**Independent Review
of
Basement Impact Assessment for
planning application 2015/3151/P
at**

**The Greenwood Centre
37 Greenwood Place
London
NW5 1LB**

**for
London Borough of Camden**

Report Ref: **LBH4355 Ver 1.0**

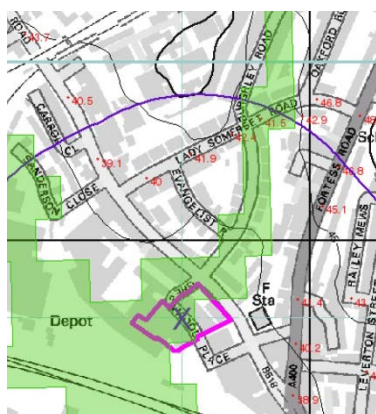
The BIA scoping is considered to be inadequate in two respects where an incorrect "NO" has been returned to screening questions (Subterranean Flow Q2 and Stability Q8 and Surface Water Flow Q6).

The BIA suggests that the course of a tributary of the River Fleet crosses the site.

This inset extract of the CGHHS Fig 2 suggests that the proposed basement lies directly on the river channel. The flood map extract below also suggests the course of a natural valley in the area of the site.

Although the fleet sewer may well provide flood alleviation that diverts water out of the original stream channel, the proposed basement may effectively impound the buried channel and the construction of a groundwater diversion may be necessary in order to preserve the natural flow of groundwater along the natural stream course.
